**ADDENDUM
NO. 4**

April 21, 2022

**RIVER VALLEY HIGH, MIDDLE, & ELEMENTARY SCHOOLS
ADDITIONS & RENOVATIONS
15480 Three Oaks Road
Three Oaks, MI, 49128**

This Addendum consists of Pages ADD 4-1, RFI Log, and Cordogan Clark Addendum No. 4, dated April 20, 2022, consisting of 5 pages, and Revised Drawings: C8, A6.6, A8.4, A9.2, M1.1D, M2.1A, M2.1D, M2.2B, M4.0, P2.1D, E2.1A, E2.1B, E2.1C, E2.2A, E2.2B, and E2.2C.

TYPE 'C' BARRIER CURB

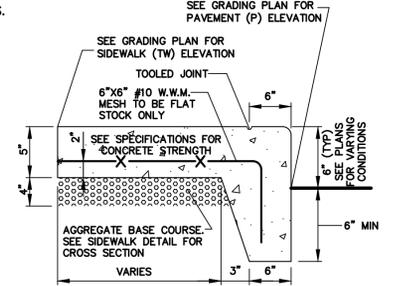
| 57 | Pearson | 4/8/2022 | Please clarify where and the extent of the type C barrier curb shown on sheet C-8 goes. | CC: See Addendum 002, sheet C-2 for call out |

SYSTEM DESCRIPTION

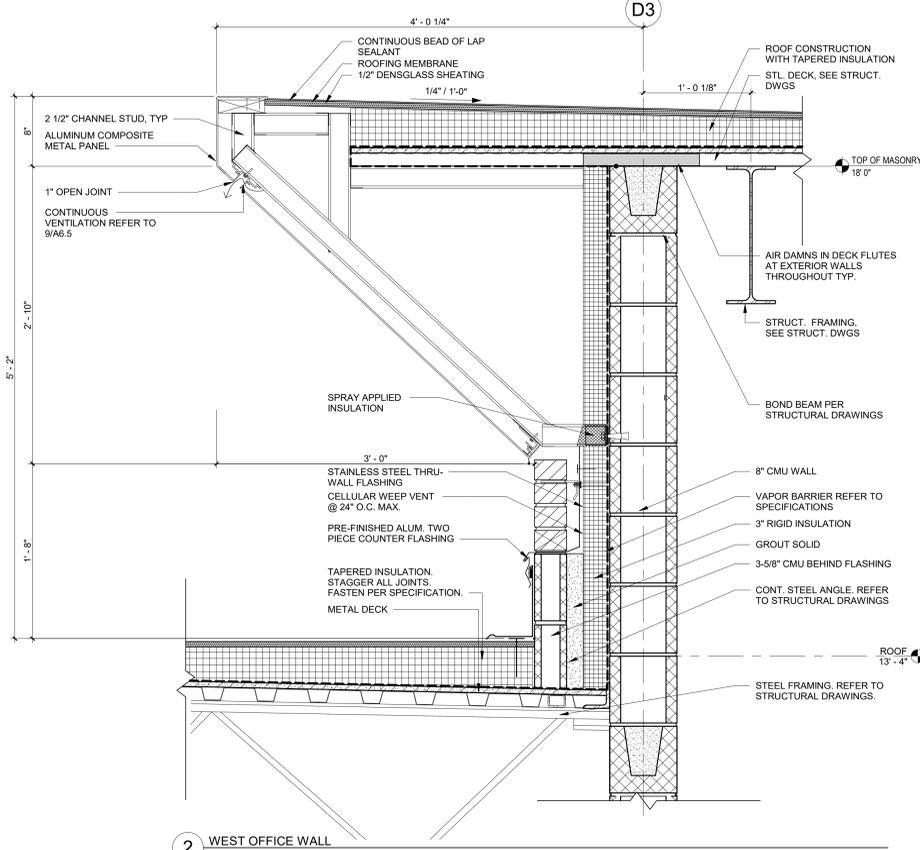
Sheet C11 SANITARY LIFT STATION PLAN

- REVISE PER ATTACHED CUT SHEETS AND SYSTEM DESCRIPTION

1 PARTIAL ROOF MECHANICAL PLAN - AREA B
 1/8" = 1'-0"

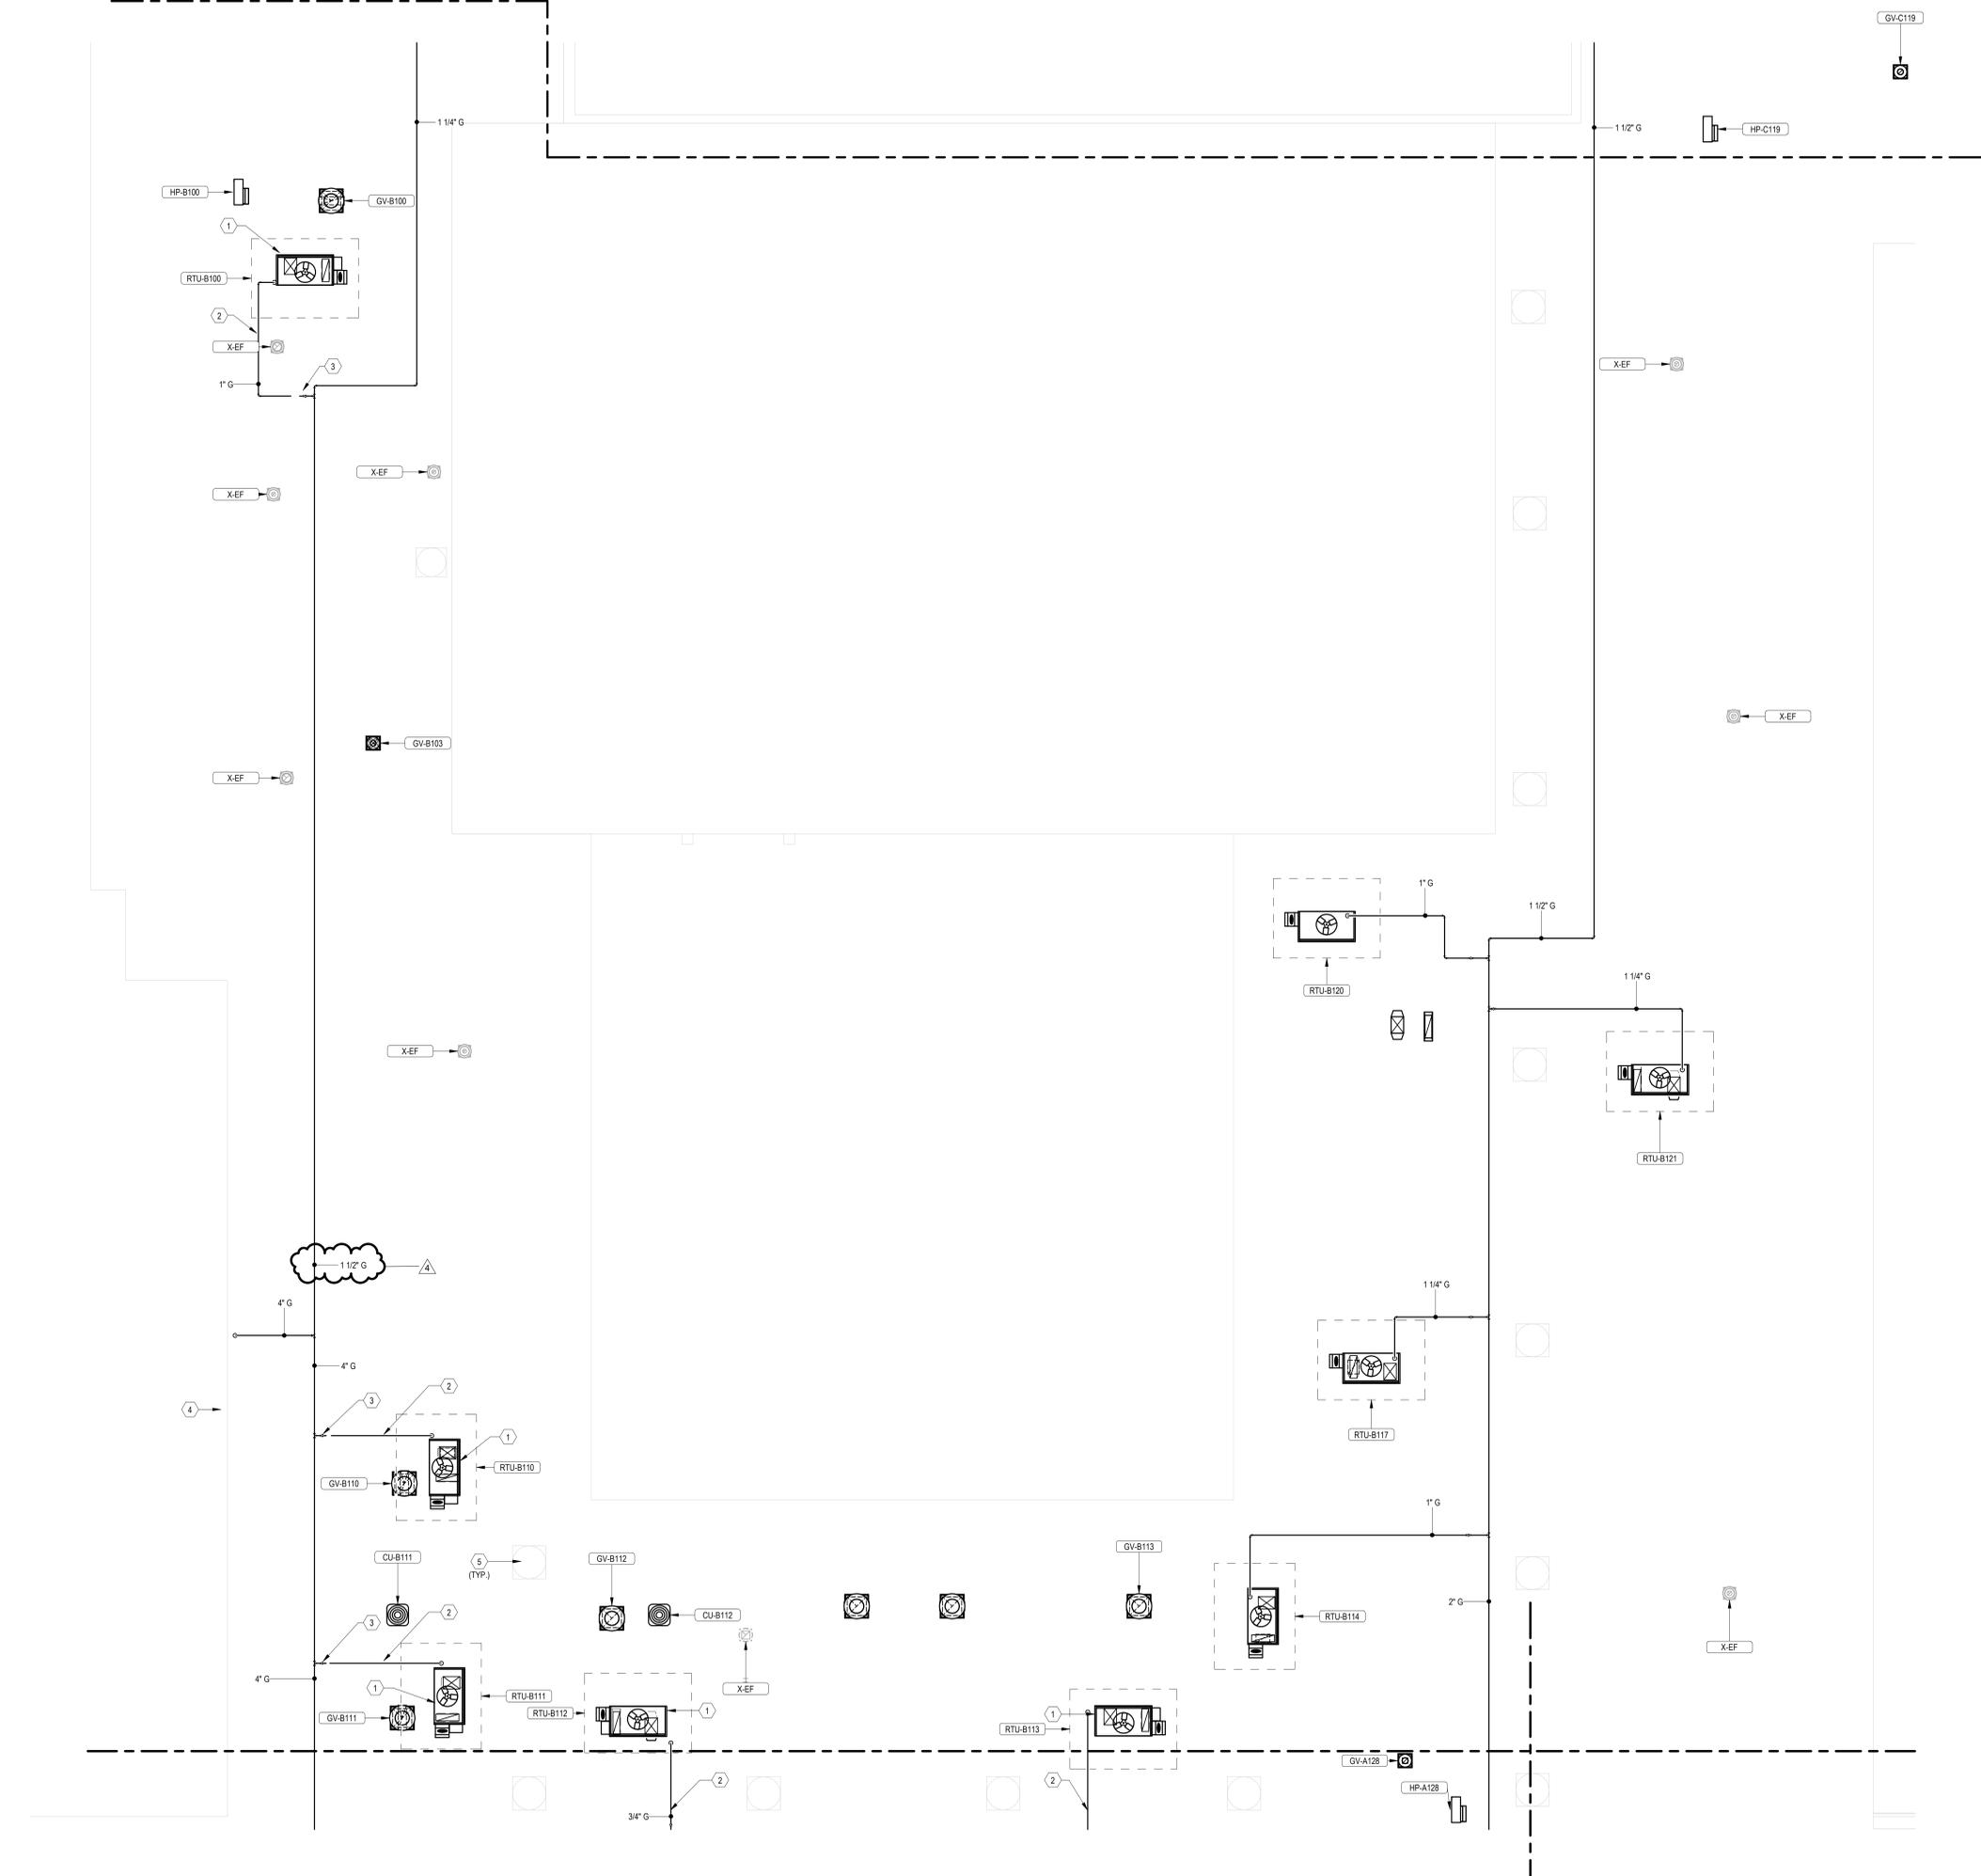
Sheet M2.2B

- REVISE gas line size tag from 1-1/4" to 1-1/2". The gas main services RTU-B100 and RTU-C100.
